SUBJECT: Wolf Creek Generating Station - Amendment No. 1 to Facility Operating License NPF-42

Amendment No.1
License No. NPF-42

ATTACHMENT TO LICENSE AMENDMENT NO. 1

SAFETY EVALUATION BY THE OFFICE OF NUCLEAR REACTOR REGULATION

FIGURE 3.2-1
WOLF CREEK UNIT 1
AXIAL FLUX DIFFERENCE LIMITS AS A FUNCTION OF RATED THERMAL POWER

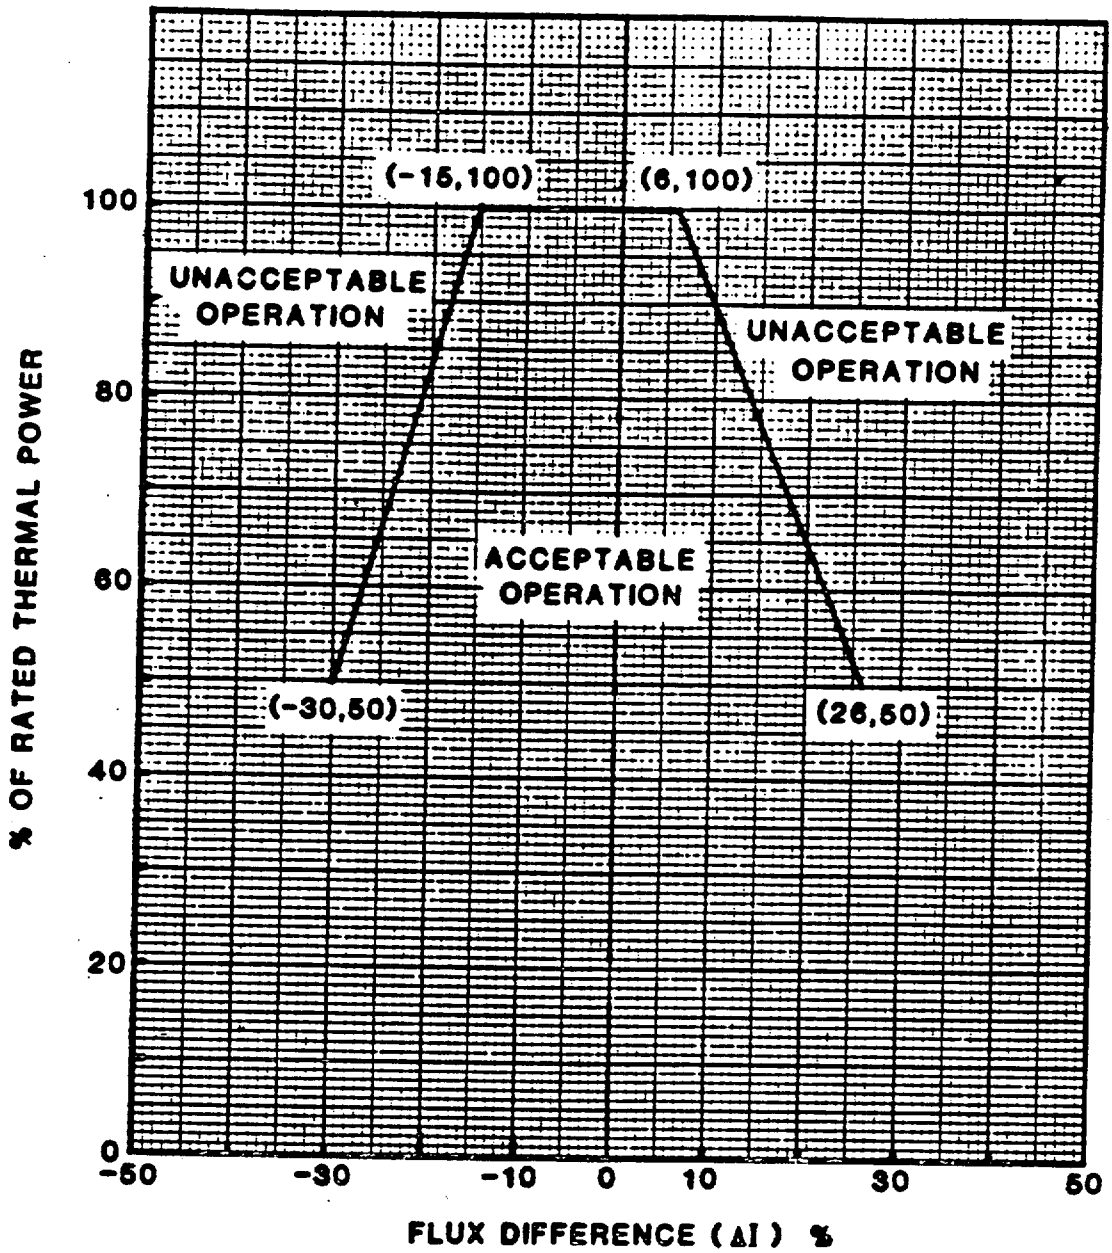
3.2.1 The indicated AXIAL FLUX DIFFERENCE (AFD) shall be maintained within the allowed operational space defined by Figure 3.2-1.

a. With the indicated AFD outside of the Figure 3.2-1 limits,

1. Either restore the indicated AFD to within the Figure 3.2-1 limits within 15 minutes, or

b. THERMAL POWER shall not be increased above 50% of RATED THERMAL POWER unless the indicated AFD is within the Figure 3.2-1 limits.

The affected sections of the Technical Specifications are: 3/4.2.1, Figure 3.2-1, Table 2.2-1, and Bases Section 3/4.2.1 and Figure B 3/4.2.1. The changes have all been made in accordance with those outlined in WCAP-10216PA. The procedure outlined in WCAP-10216PA was used for the analysis performed by Westinghouse for Cycle 1 of the Wolf Creek Generating Station Unit 1. The analysis is applicable only after the unit reaches 8000 MWD/MTU burnup in Cycle 1 and thereafter until the end of Cycle 1. Cycle specific evaluations are made

We have reviewed the submittal for the RAOC technical specification change for Wolf Creek; the methodology used has previously been reviewed and approved by the staff. The proposed technical specification changes are those outlined in the topical (WCAP-10216PA). Therefore, the proposed technical specification changes are acceptable.
